Mitigation Plan  
Hornpipe Branch Tributaries  
Mitigation Project  
Lenoir County, North Carolina  
FINAL VERSION

NCDEQ DMS Project Identification # 100076  
NCDEQ DMS Contract # 7605  
Neuse River Basin (Cataloging Unit 03020202)  
USACE Action ID Number: SAW-2018-01762  
DWR Project #20-0048  
Contracted Under RFP # 16-007401

**RE: WLS Responses to NCIRT 30-day Review Comments Regarding Task 3 Submittal, Final Mitigation Plan Approval for the Hornpipe Branch Tributaries Mitigation Project, USACE AID# SAW-2018-01762, NCDEQ DMS Full-Delivery Project ID #100076, Contract #7605, Neuse River Basin, Cataloging Unit 03020202, Johnston County, NC**

Figure 9 – Proposed Mitigation Features Map

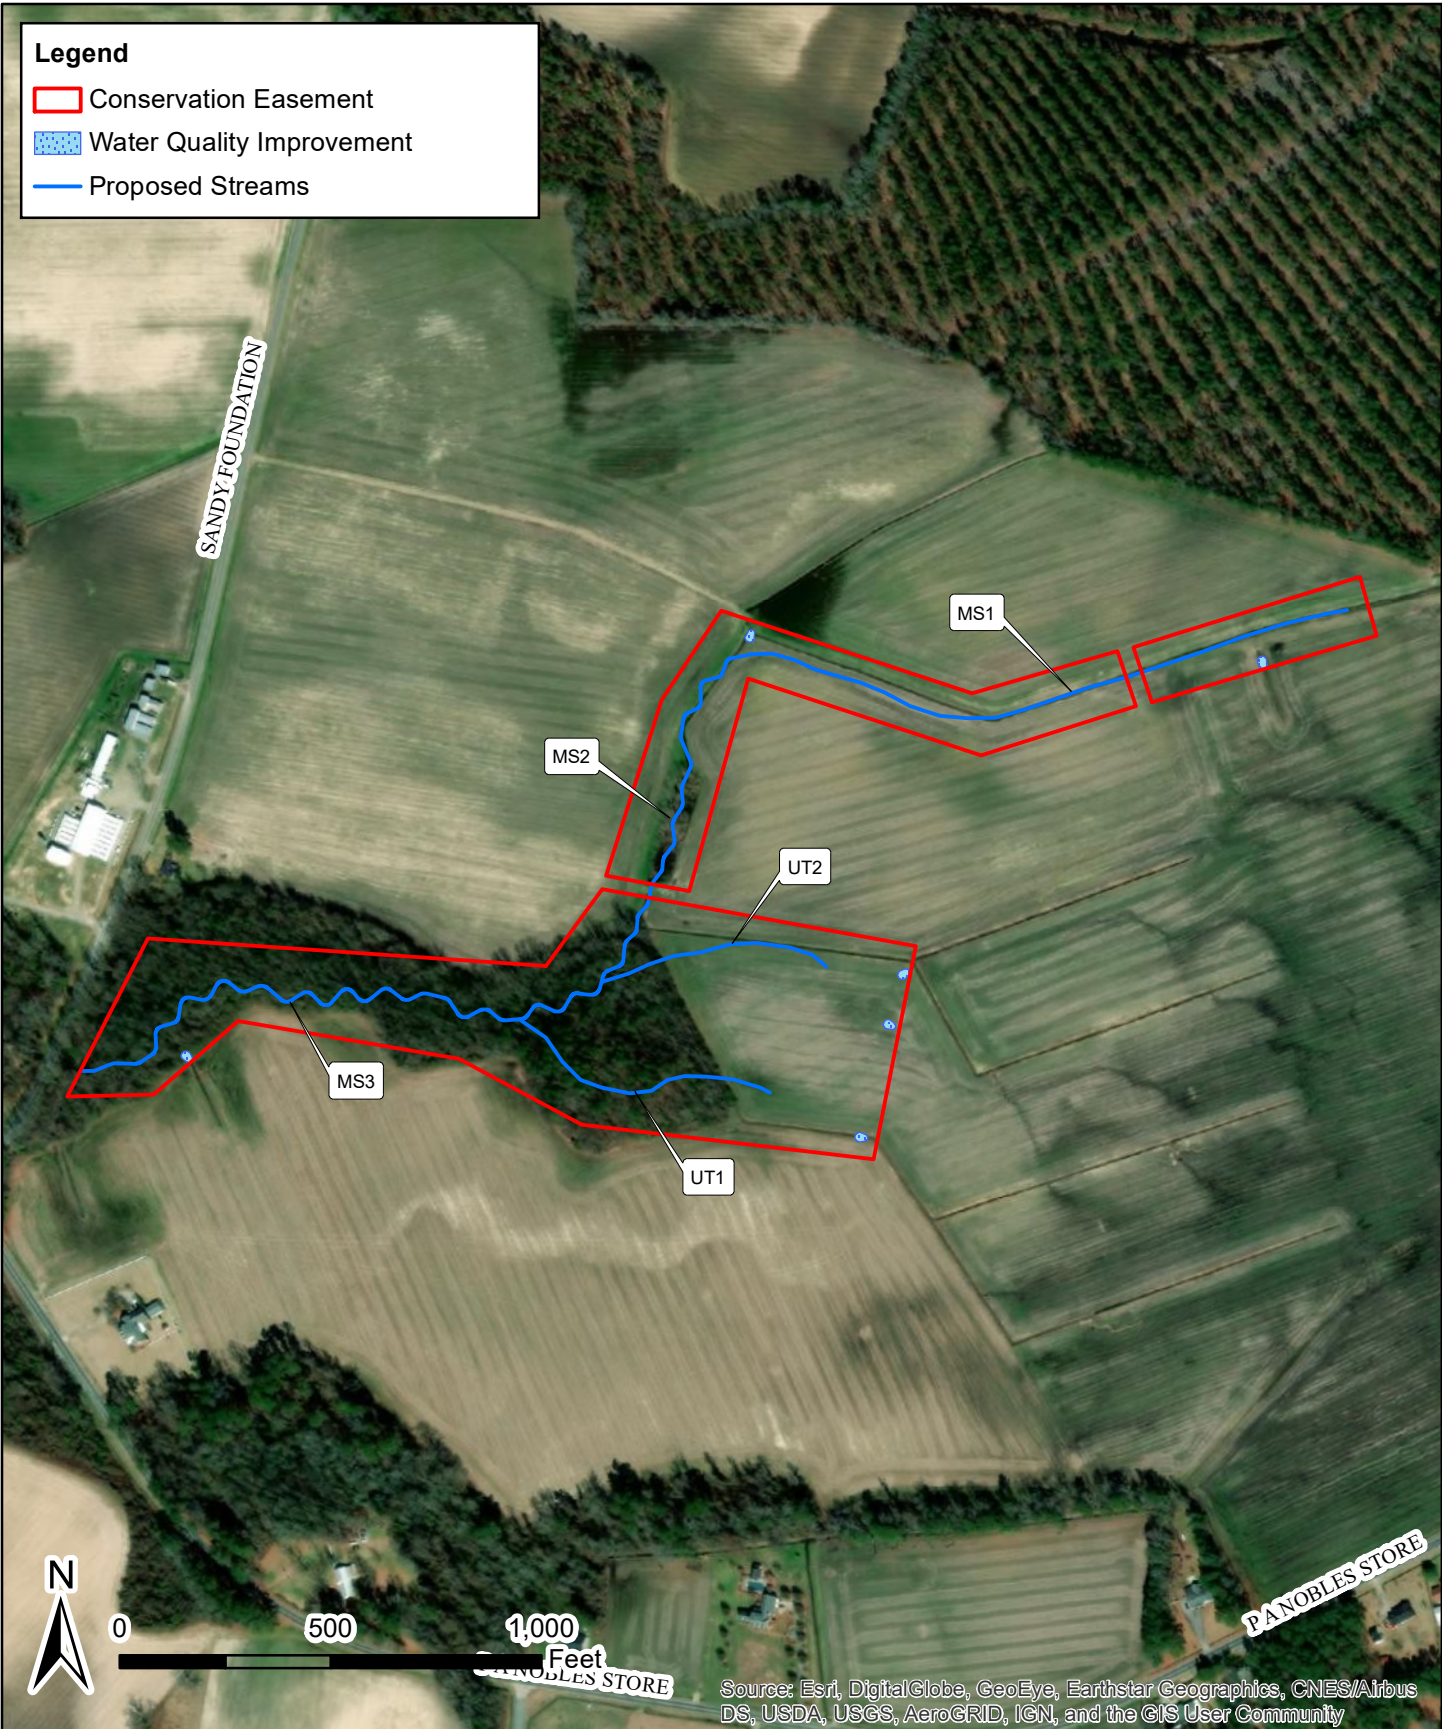
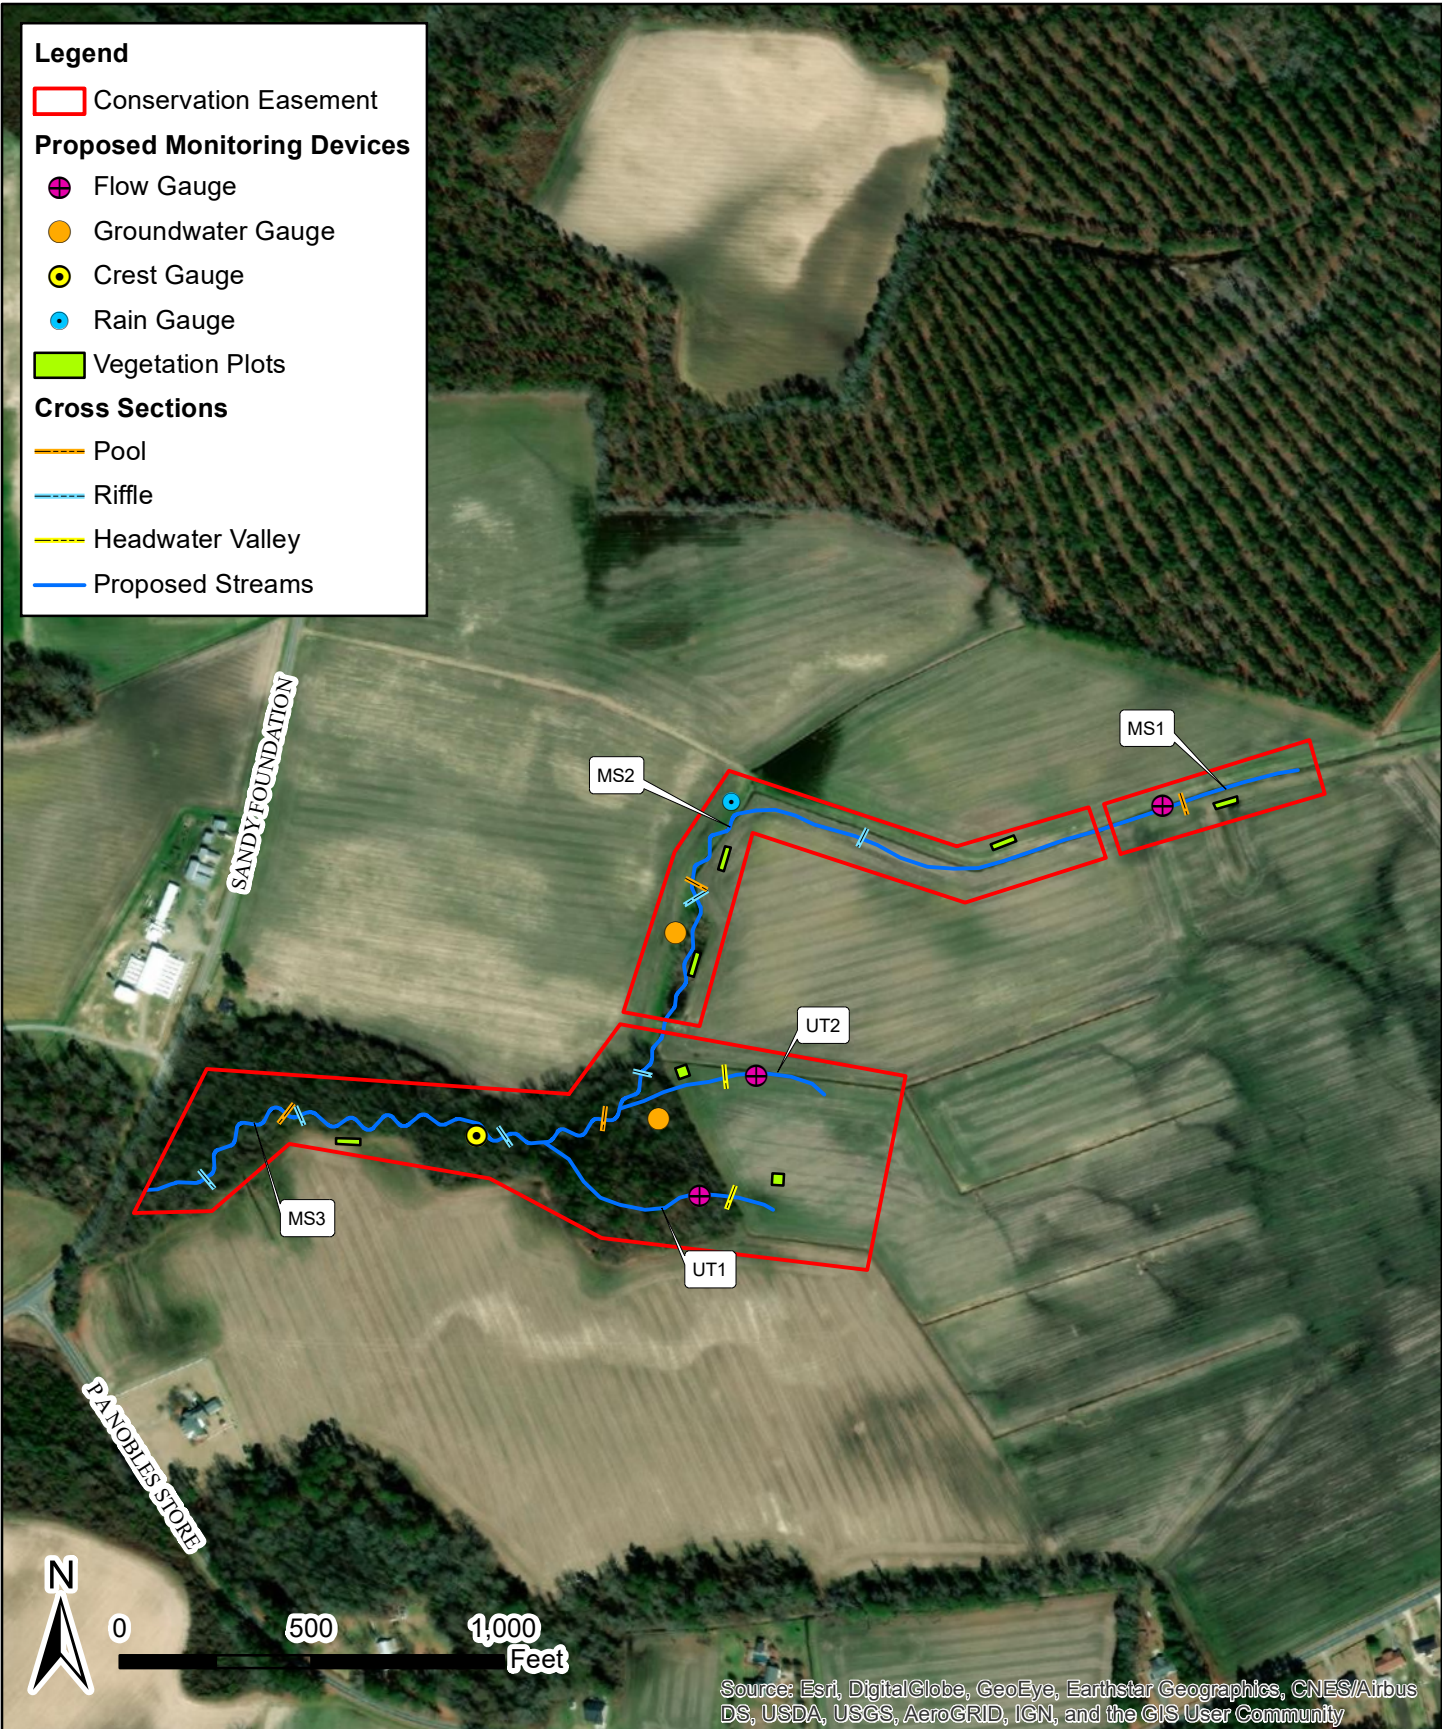
**10. Design sheet 14-The upper reach of UT2 shows two branches while in Figure 9 there is only one stream/valley. Are your valley footage calculations based on one valley length as in Fig. 9 or two as in sheet 14? DWR does not agree with there being two valleys at the top of UT2. Moreover, DWR is concerned with the top of both UT1 and UT2. Are the tops of both these reaches designed to accept the flow from the offsite ditches? If so, what if the landowner decides to cut a new ditch and thereby remove your primary hydrologic input?** Response: WLS is not proposing an additional valley or stream credit at the top of UT2. The mitigation credits proposed in Table 1 and shown on design plan sheet #1 are based on valley length for headwater reaches UT1 and UT2. The creditable stream length begins at UT2 station 10+28 and UT1 station 10+68 respectively. The tops of both of these reaches are designed to accept flow from offsite ditches. We have added a note in Table 1 for clarification. As noted in DWR response comment #2, the upper headwater catchments are in agricultural fields, however the ditch network that flow into reaches UT1 and UT2 must remain open and active to maintain surface flow and drainage for crop production. WLS has coordinated closely with the landowner to ensure the ditches and drainage paths will not be altered post-restoration.

**4. Please ensure that the water quality BMPs proposed for UT1 and UT2 are not within the jurisdictional feature. Figures 9 and 10 show inconsistent origins of these two reaches.** Response: The water quality features proposed for UT1 and UT2 are not within jurisdictional stream features. The proposed stream origins are located within the naturally restored headwater valleys and correct as shown in Figures 9 and 10.

**5. Please add a veg plot to the area along MS2 where the existing wetland is.** Response: A vegetation plot has been added in the existing wetland area and can be seen on Figure 10.

**12. Section 8.1: Please show the location of the fixed photo points on Figure 10. If cross-sections are to be used for photo points, please indicate in the text. Additionally, it would be helpful to have photo points at crossings to show the condition of the culverts.** Response: Language has been added to Section 8.1 stating that the fixed photo points are to be located at the cross-sections. A photo point at the two crossing locations will be added as well and will be shown on the monitoring CCPV map.

**13. Please show the location of the rain gauge on Figure 10.** Response: The location of the rain gauge has been added to Figure 10.
